**CORPORATION OF SHEPHERDSTOWN
JEFFERSON COUNTY, WEST VIRGINIA**

CONTRACT NO. 1 – NEW STREET UTILITY IMPROVEMENTS

ADDENDUM NO. 1

USER: bryon s. querrey
 LAYOUT: Sheet 2 ADD 1
 PLOT DATE/TIME: 4/5/2018 9:26 AM
 CAD FILE: R:\020-1507-SHEPHERDSTOWN - UTILITY IMPROVEMENTS-\Drawing\Sheet 2, 3, 3A.dwg (Piping Profile).dwg

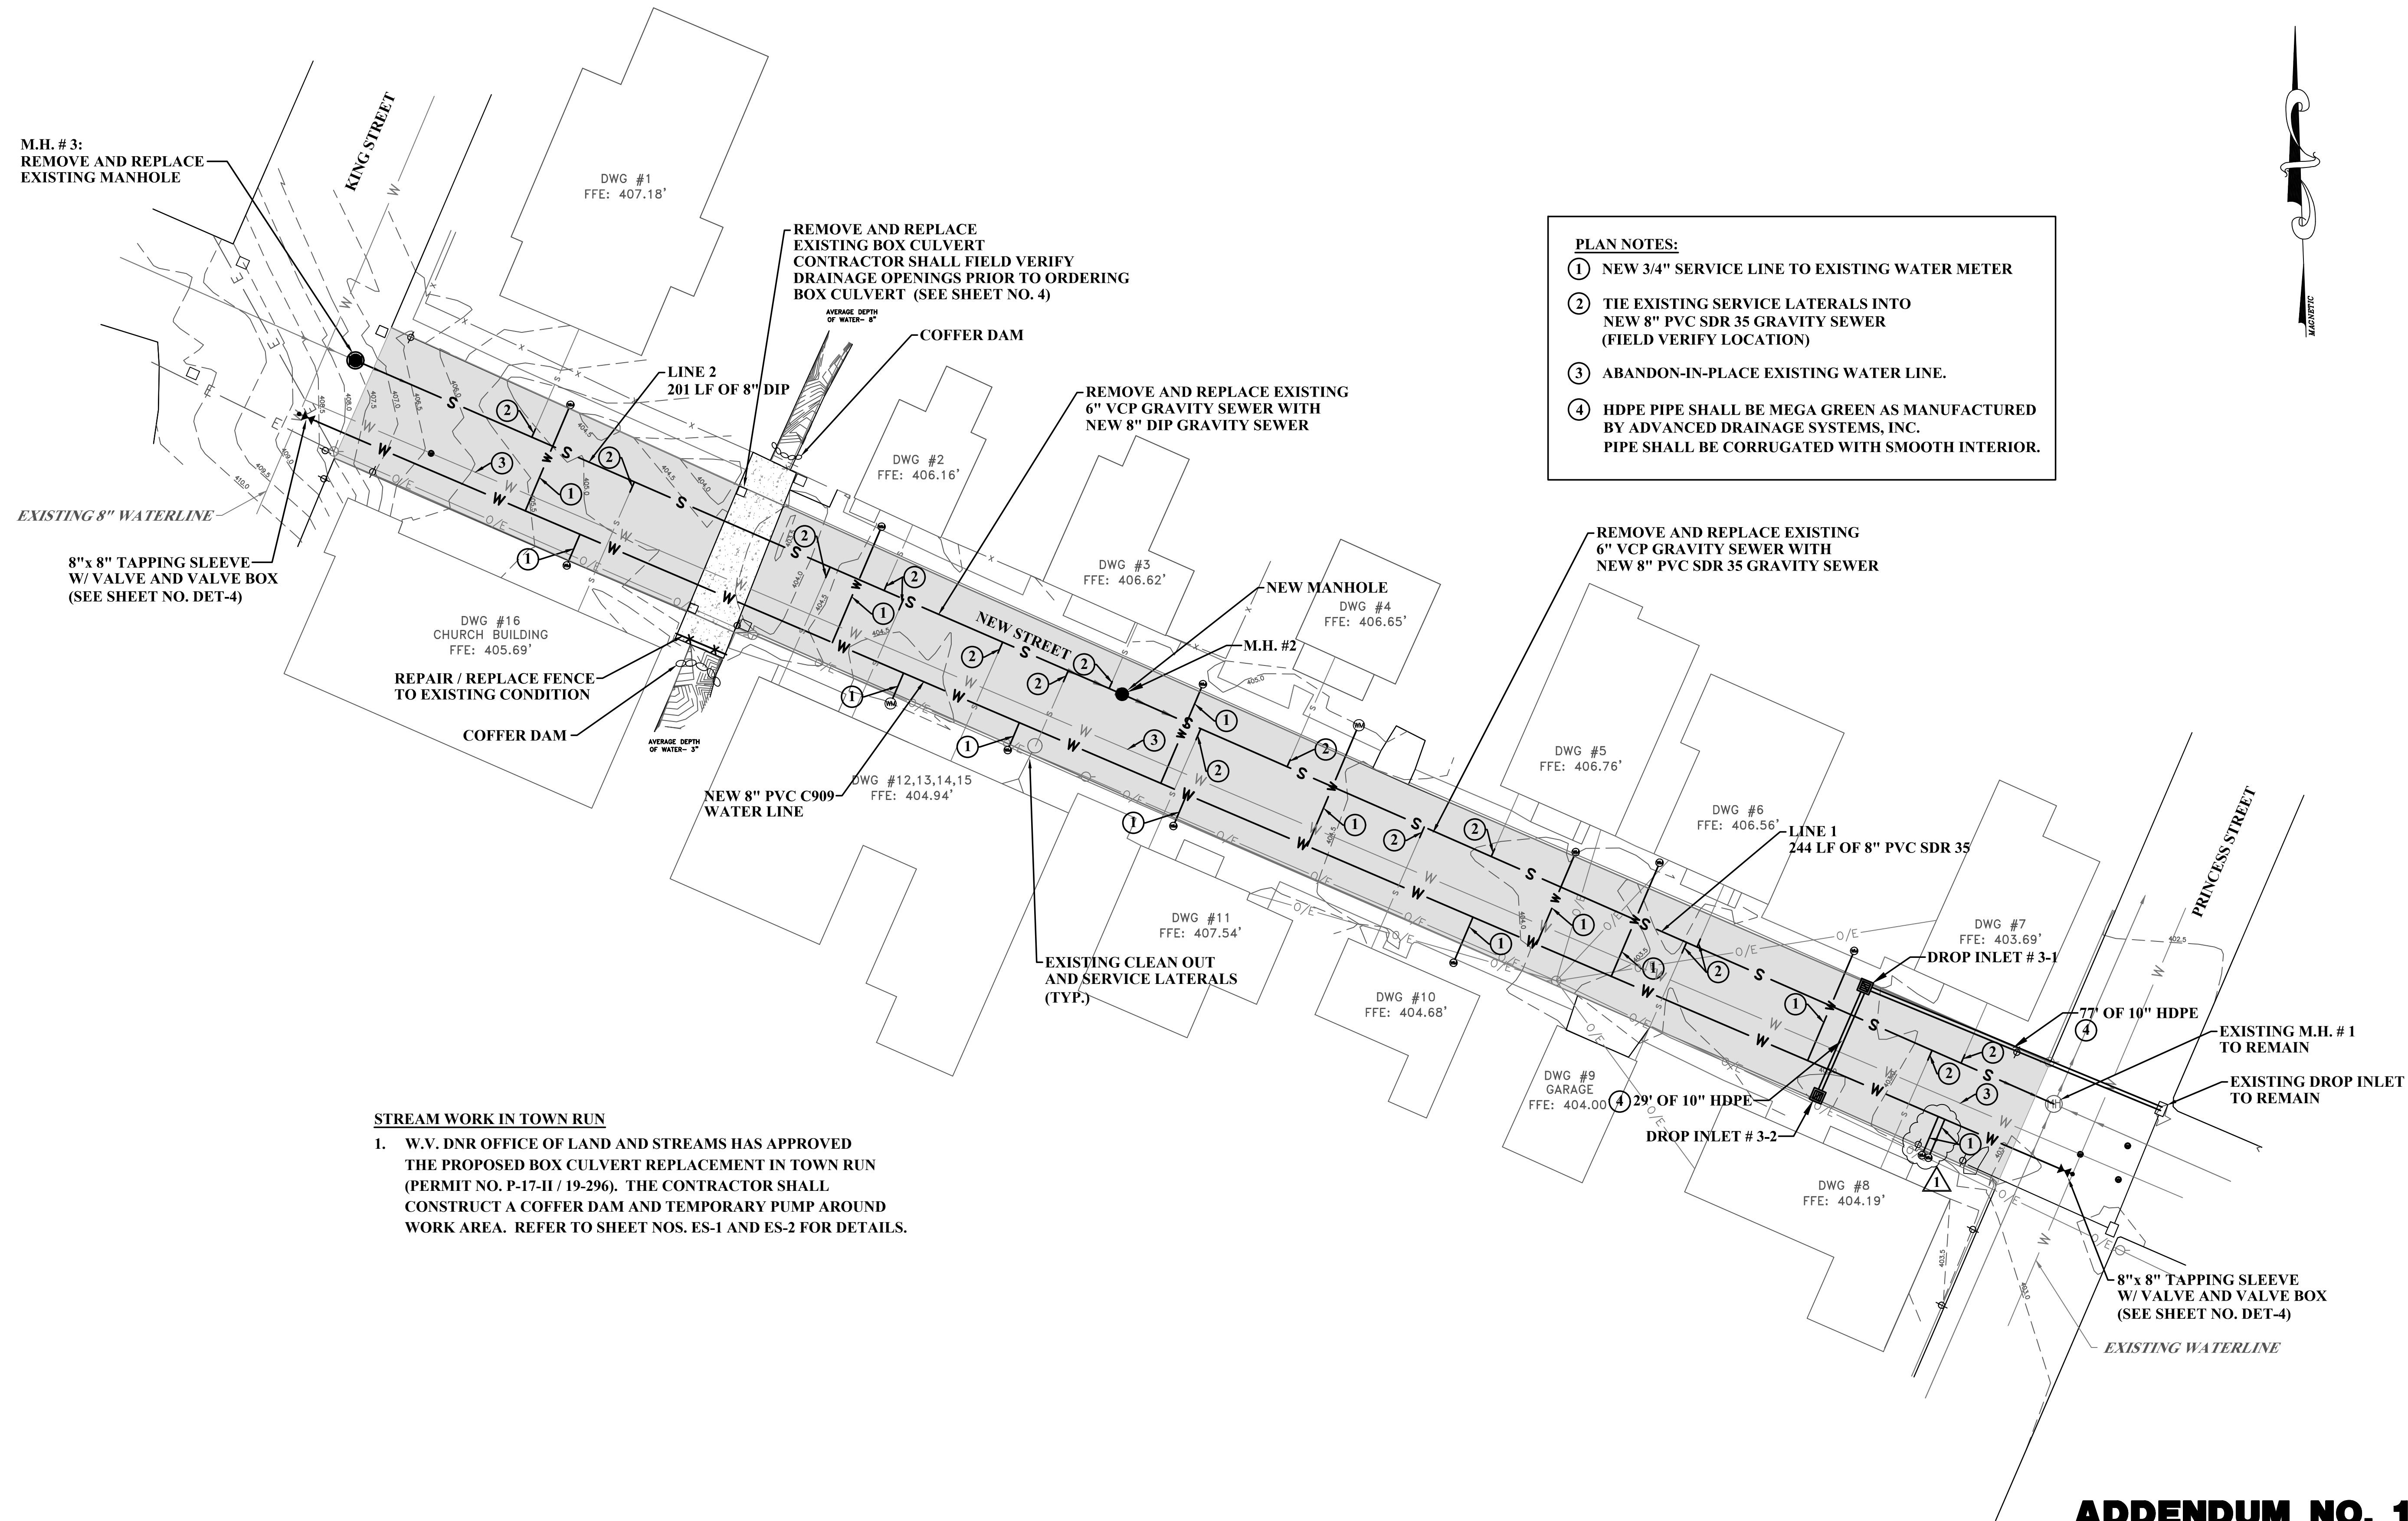
1. Sheet No. 2 – The one (1) inch service line serving DWG #8 shall be replaced with two (2) separate 3/4 inch service lines.
2. Sheet No. SW DET – An 8-1/2” x 11” sheet of a “Typical Sidewalk Section” Detail is enclosed with this Addendum No. 1.

NO.	BY	DATE	DESCRIPTION
1	BSQ	4/2018	ADDED SEPERATE WATER SERVICE LINES AND REVISED NOTE NO. 3
